PREVOST

WARRANTY BULLETIN

WB17-06

DATE :	March 2017	SECTION :	23 ACCESSORIES
EXPIRATION:	March 2017		
SUBJECT :	WCL PENDANT SUPPORT IMPROVEMENT

Figure 1 : Wheelchair lift control pendant

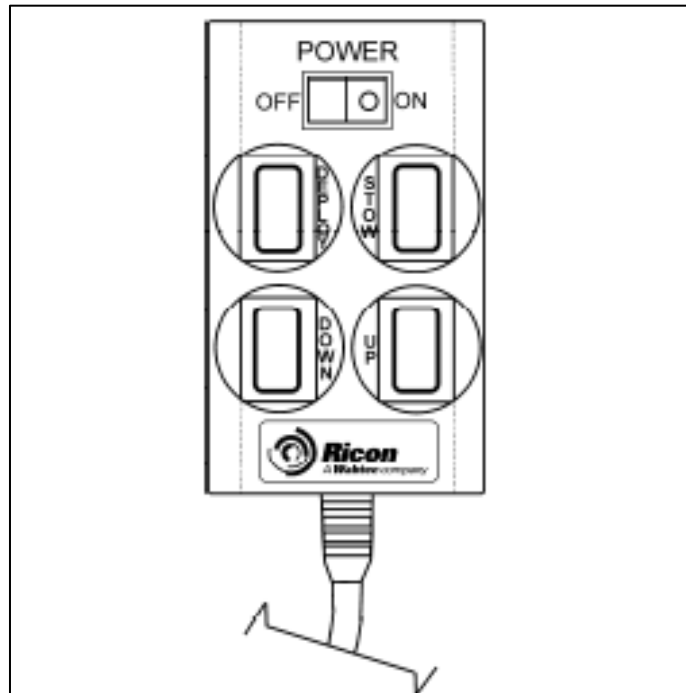
The yellow control pendant is larger than the black model and in certain conditions is harder to hook on the existing bracket.

Figure 2

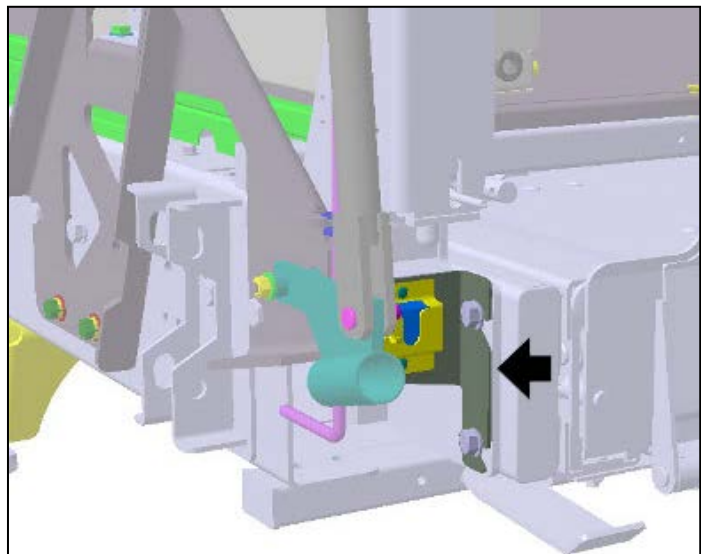
2. Remove the small bracket assembly on the left side of the platform. (Arrow, Figure 2.)

Figure 3

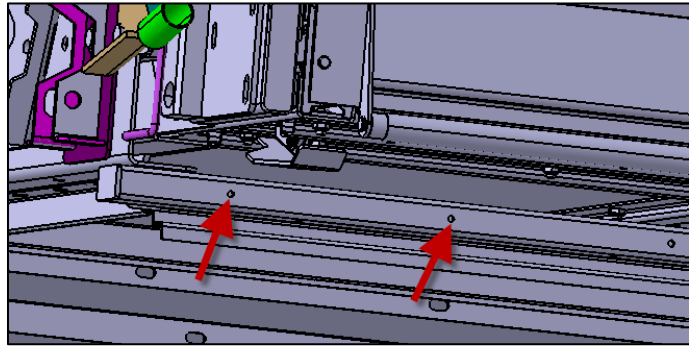
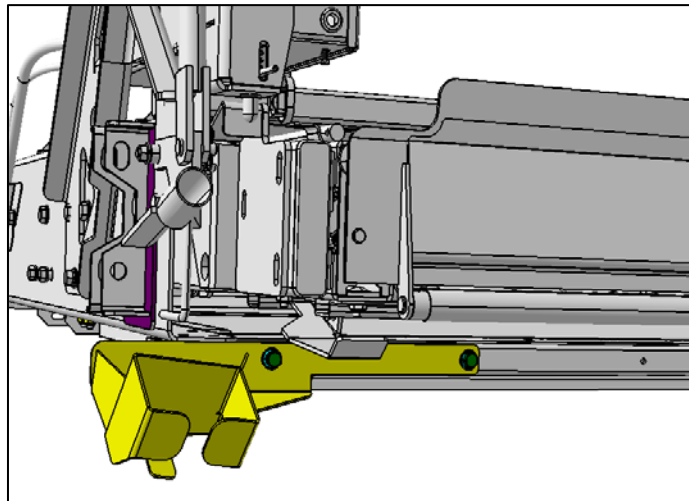
-
4. Install new bracket #364388 with screws 502772 and lock washers 500356.
Place mounting screws in first two left side holes under the platform.
Tighten to: **96 lb-in**

Figure 5

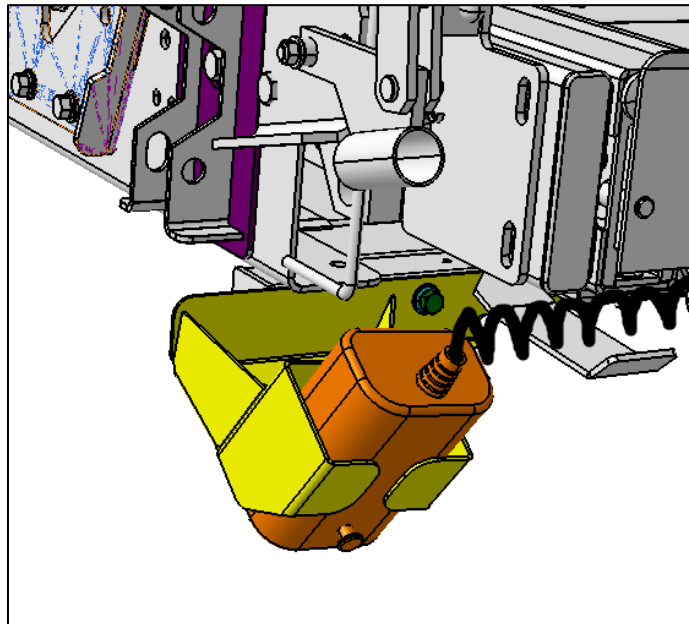
-
5. Place pendant in bracket, pushbuttons upside.
